LETTER AND U S NAVY RESPONSE TO U S EPA REGION I AND RHODE ISLAND
DEPARTMENT OF ENVIRONMENTAL PROTECTION COMMENTS REGARDING DRAFT
SAMPLING AND ANALYSIS PLAN FOR TANK FARM 1 ETHYL BLENDING PLANT NS
NEWPORT RI
07/28/2011
TETRA TECH NUS

Subject: Transmittal of Response to Comments, Draft Sampling and Analysis Plan
Ethyl Blending Plant, Tank Farm 1
Naval Station Newport, Newport RI

**NAVY RESPONSES TO U.S. ENVIRONMENTAL PROTECTION AGENCY (EPA)
COMMENTS DATED JUNE 3 2011
SAMPLING AND ANALYSIS PLAN FOR THE DATA GAPS ASSESSMENT
ETHYL BLENDING PLANT, SITE 07, TANK FARM 1 (APRIL 2011)**

**NAVY RESPONSES TO RHODE ISLAND DEPARTMENT
OF ENVIRONMENTAL MANAGEMENT (RIDEM)
COMMENTS DATED JUNE 6 2011
SAMPLING AND ANALYSIS PLAN FOR THE DATA GAPS ASSESSMENT
ETHYL BLENDING PLANT, SITE 07, TANK FARM 1 (APRIL 2011)**

PLANNED SOIL SAMPLING LOCATIONS
 CATEGORY 1/ETHYL BLENDING PLANT
 TANK FARM 1
 NAVSTA, NEWPORT
 PORTSMOUTH, RHODE ISLAND

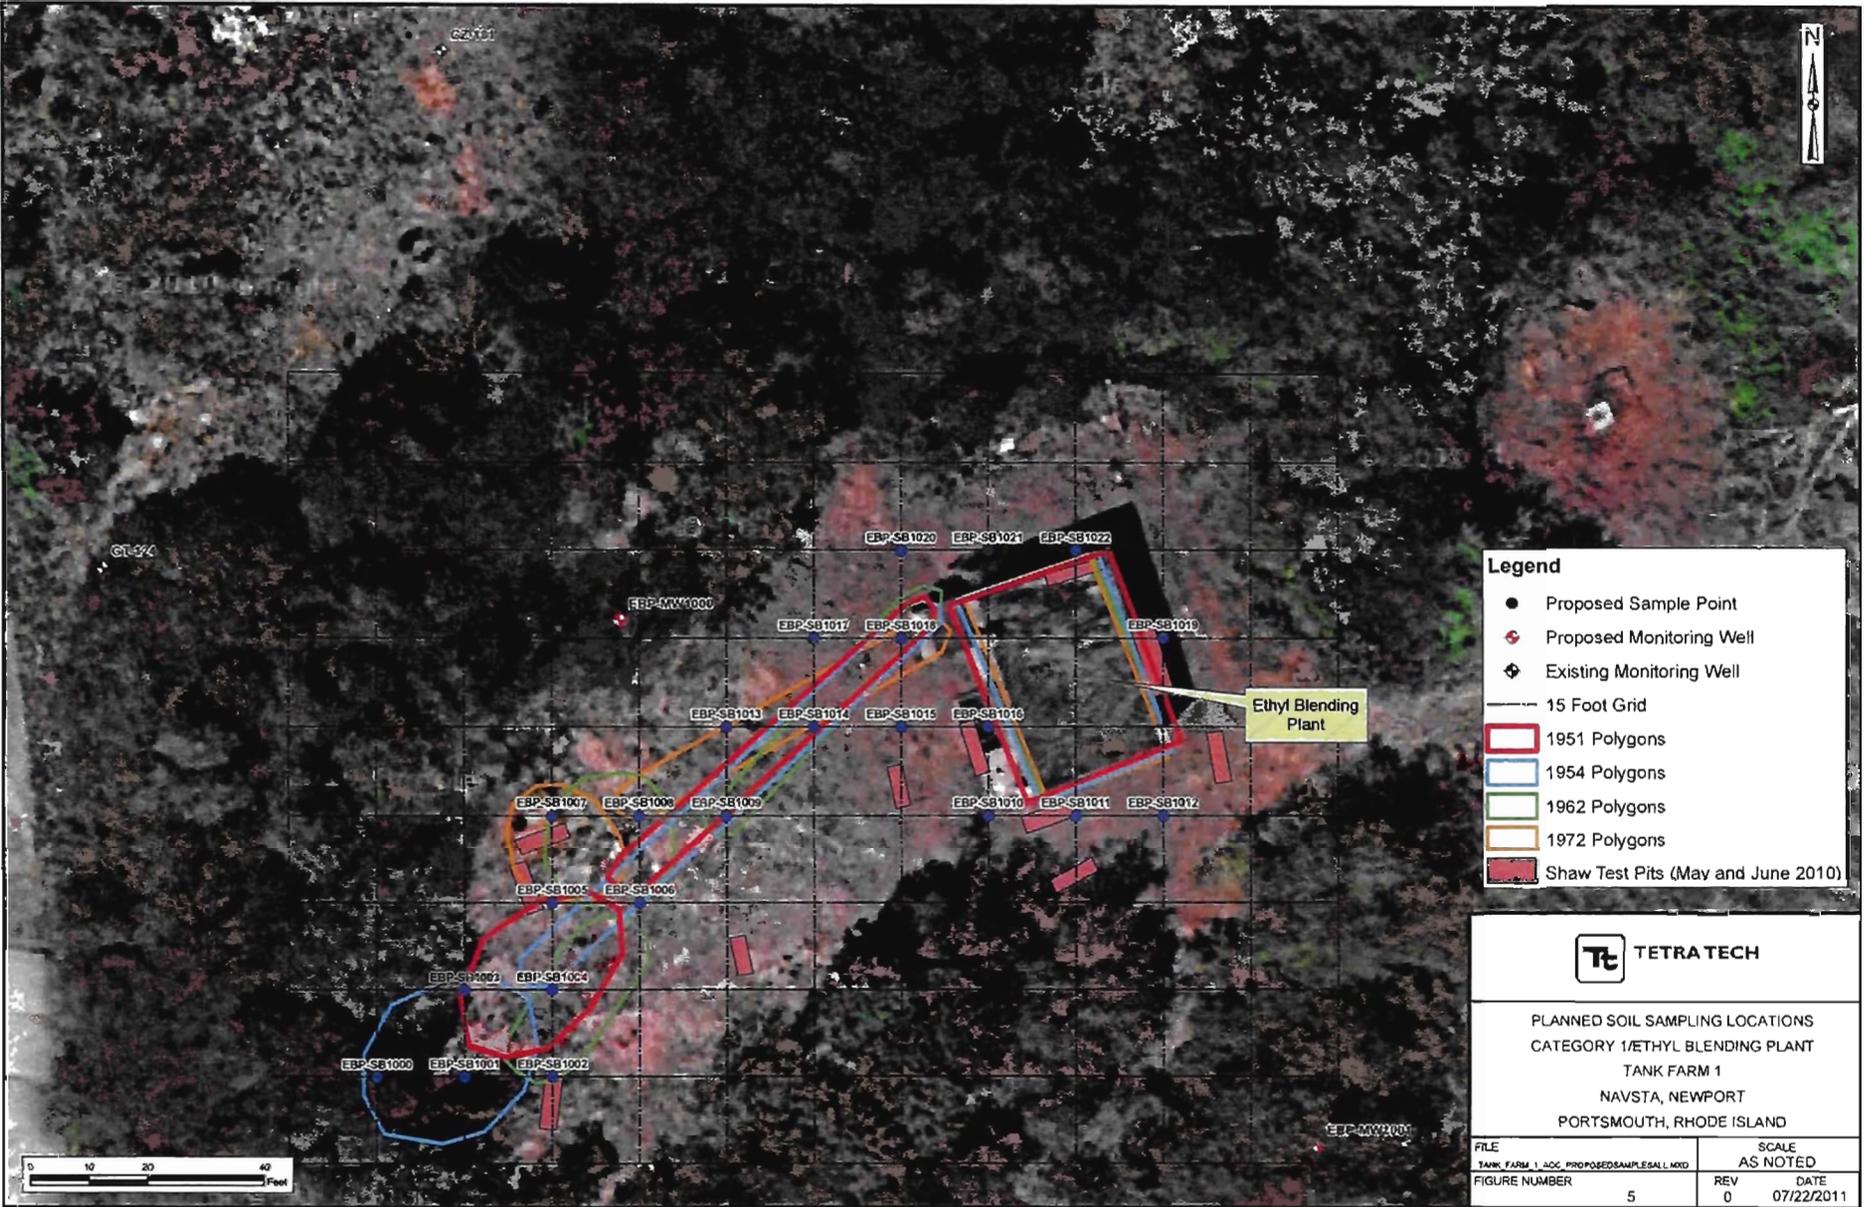
Comment 26: Figure 5:

a) Please supplement the sampling plan with at least four additional borings immediately adjacent to the four sides of the ethyl blending building.

b) The established grid for sampling proposes very few samples within the limits of the AOCs. This is not acceptable. Most of the samples should be collected within the boundaries of the AOCs, to document the presence or absence of contamination, with some additional samples located around the perimeters to attempt to characterize the extent of contamination. Please revise the sampling plan to better characterize the AOCs.

Comment 18: Page 53, SAP Worksheet #17, Sampling Design and Rationale; whole section: The rationale and grid on Figure 5 do not appear to catch the known AOC but seem to try to catch the outskirts of the AOCs. For example, the long AOC listed as TF1-004 has no boring inside the known AOC. Please position the soil sampling location both inside and outside the known AOCs.

Comment 22: **Figure 5:** *Please provide Figure 5 on a larger fold out paper with the Shaw test pits labeled on the figure and include any laboratory test results in boxes along with the identified Shaw test pit locations. Please provide this revised Figure 5 in the response to comments.*

Response: The sample locations are based on a 15 foot by 15 foot grid system. Seven locations are adjacent to the ethyl blending plant building (SB1010 through SB1012, SB1016, SB1019, SB1021, and SB1022). Locations can be adjusted during a field verification trip.

Response: The photo interpretation of the AOCs associated with the Ethyl Blending Plant reviewed aerial photos from 1951, 1954, 1962, and 1972. This report is included in Appendix A-2 of the SAP. The size and dimensions of AOCs 4, 5, and 18 differed slightly in different years. Therefore, a grid system was incorporated to place sample locations. Figure 5 is based on the 1962 aerial photograph. Navy believes that samples are properly positioned to characterize the AOCs. Figure 5 has been revised to include the AOC polygons from each year and will be included with this response to comments document.

Response: The photo interpretation of the AOCs associated with the Ethyl Blending Plant reviewed aerial photos from 1951, 1962, and 1972. This report is included in Appendix A-2 of the SAP. The size and dimensions of AOCs 4, 5, and 18 differed slightly in different years. Therefore, a grid system was incorporated to place sample locations. Figure 5 is based on the 1962 aerial photograph. Navy believes that samples are properly positioned to characterize the AOCs. Figure 5 has been revised to include the AOC polygons from each year and will be included with this response to comments document.

Response: The Shaw Summary Report includes sample location maps and analytical results tables. Tetra Tech will draft a table that summarizes the Shaw samples collected in the vicinity of the Ethyl Blending Plant. The table will be included in Worksheet #10 of the Ethyl Blending Plant SAP. Please note that locations are depicted on the Shaw Summary Report Sample Location figure included in Attachment A-3 of the Ethyl Blending Plant SAP.

FIGURE 3-1

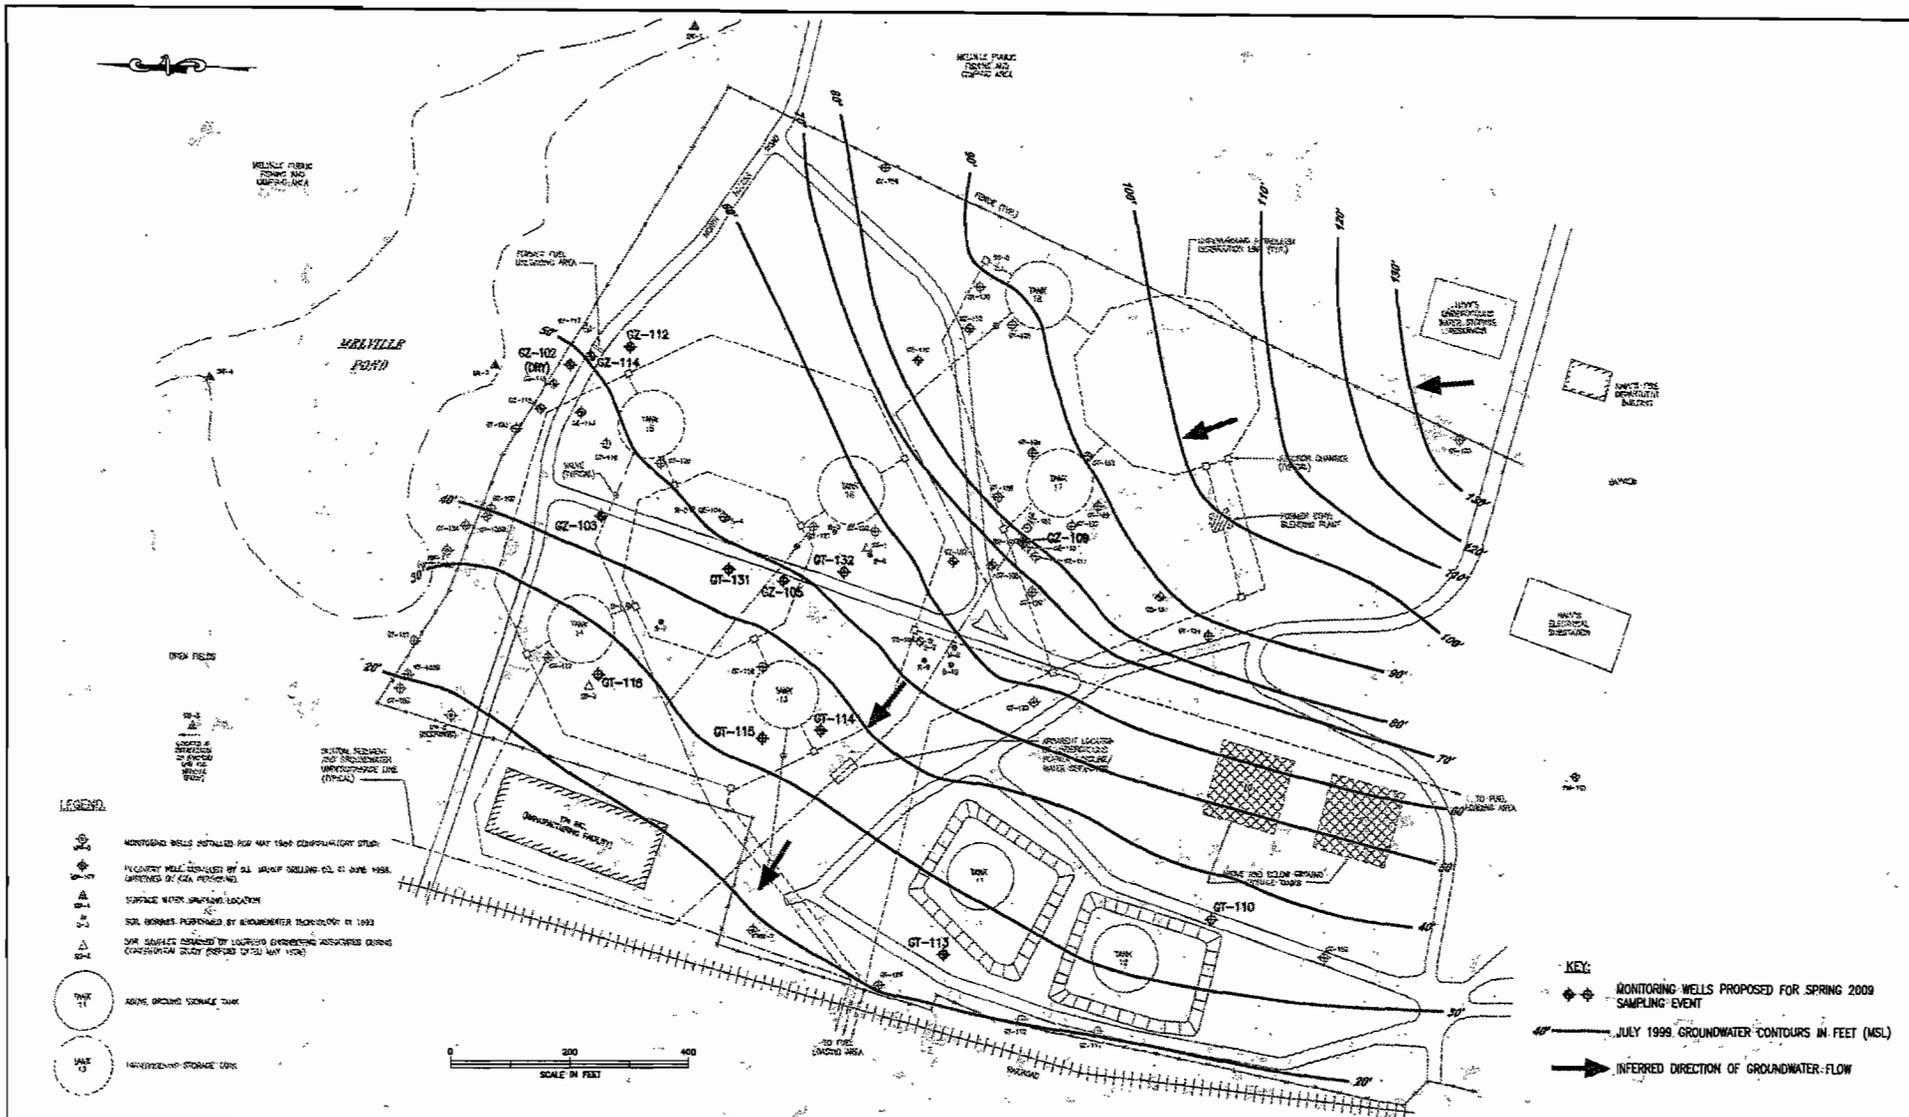
Please supplement this SAP with information confirming the groundwater contours/groundwater flow direction at Tank Farm 1 and specifically in the vicinity of the ethyl blending plant.

- A groundwater contour map included in the Tetra Tech EC 2009 groundwater monitoring round will be included with this response to comments document. Groundwater contours are likely to include any influences on groundwater flow from the ring drains.

**TANK FARM 1
PCBS SAMPLE LOCATIONS
DESC
MELVILLE, RHODE ISLAND**

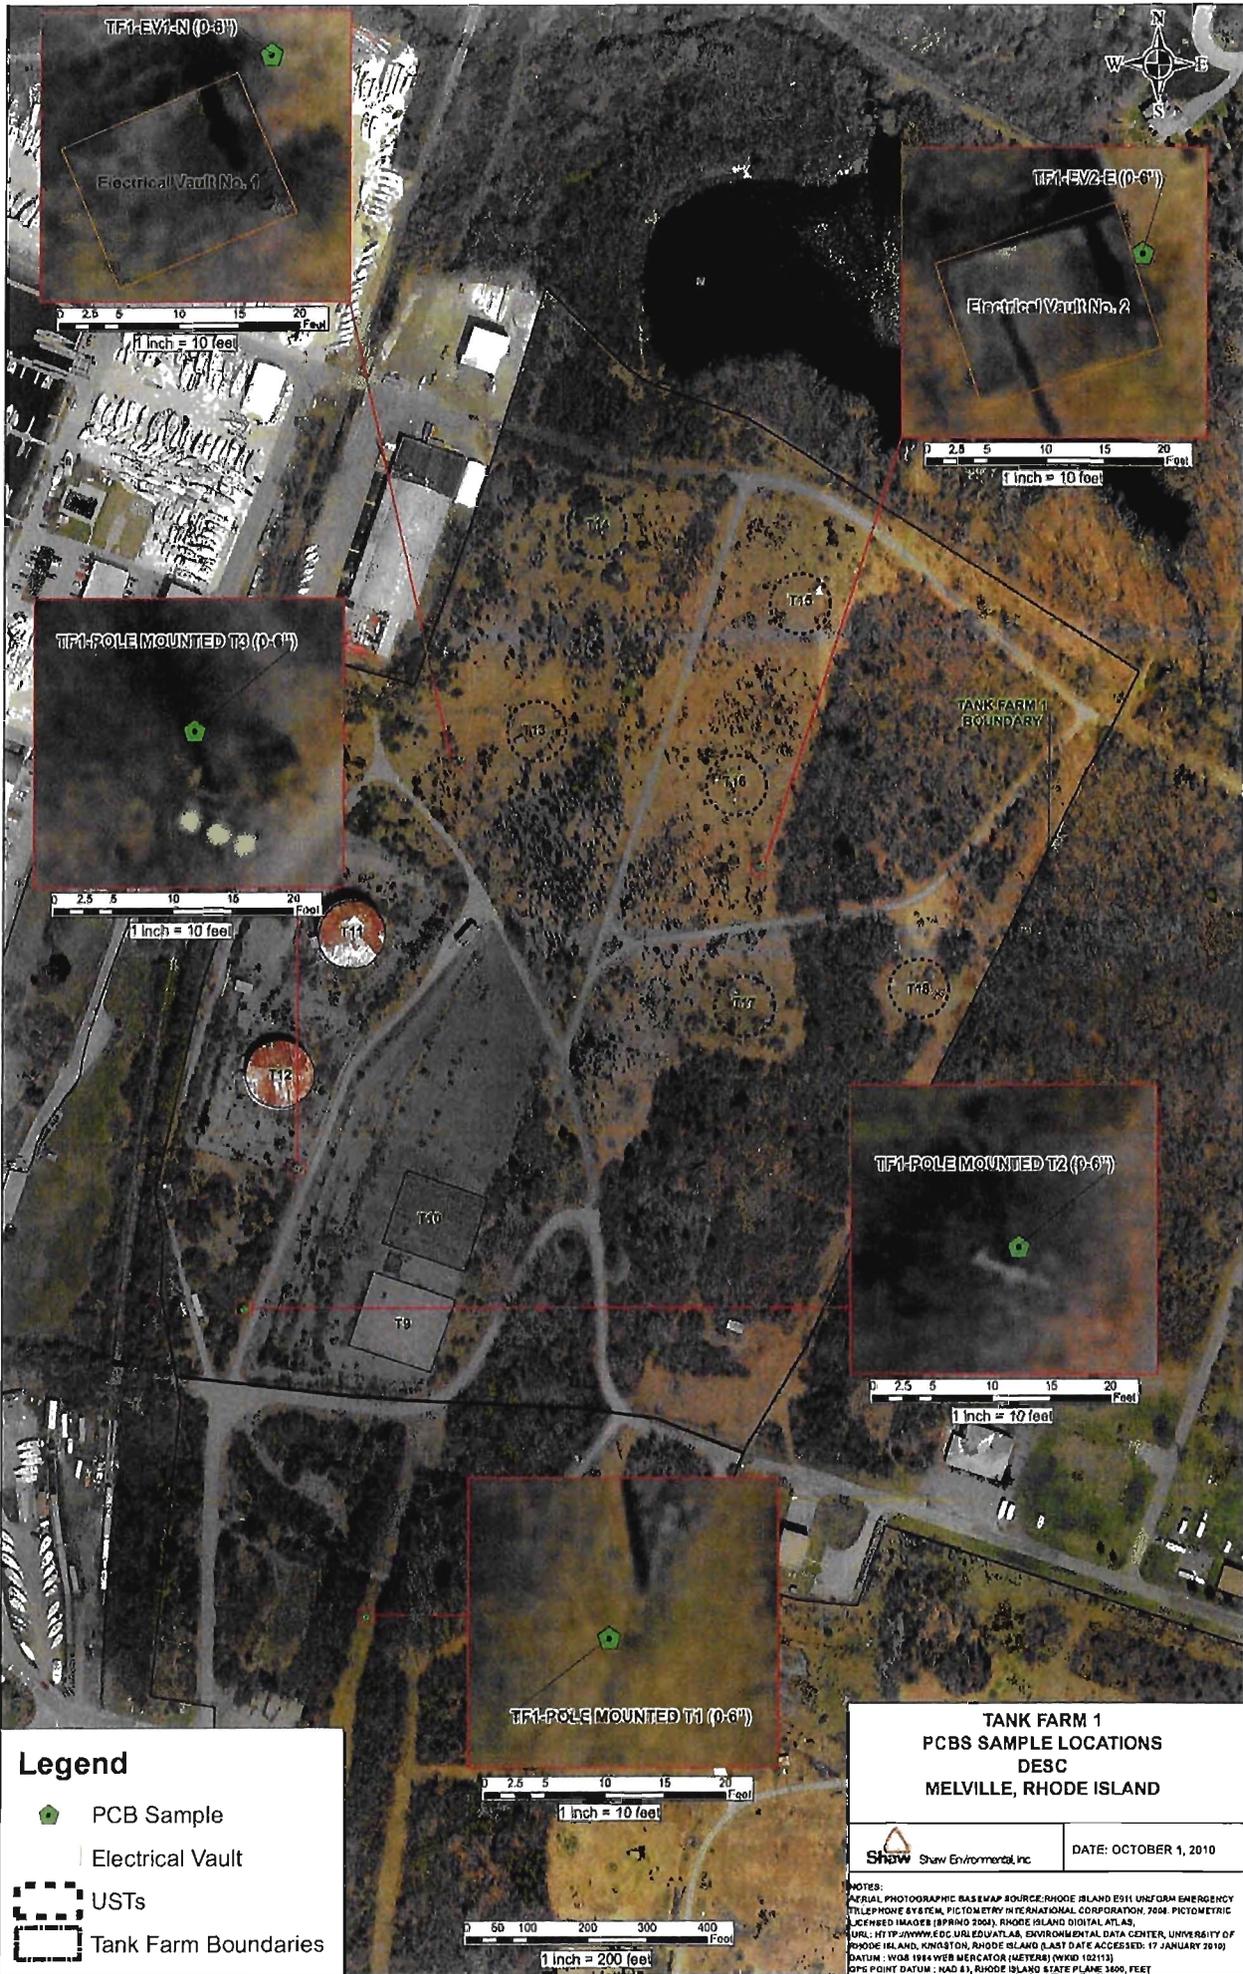
Comment 2: p. 18, Worksheet 9: Regarding the comments for the November 17, 2010 scoping session, please determine if utilities are active because if they are not, sampling at the transformers should be

included in this sampling plan. EPA notes that the Site has reportedly been inactive since the termination of DESC operations in the early 1990s so it is not clear why the utilities would be active or why this site should be considered active.

Response: Recent site activities conducted by Shaw have determined that there are several active utility lines at Tank Farm 1. These include several underground and pole-mounted electric lines. Transformers will not be included in the sampling plan due to the active status of utilities at Tank Farm 1. A report generated by Shaw documenting their PCB soil sampling in the vicinity of Tank Farm 1 transformers will be included with this response to comments document.
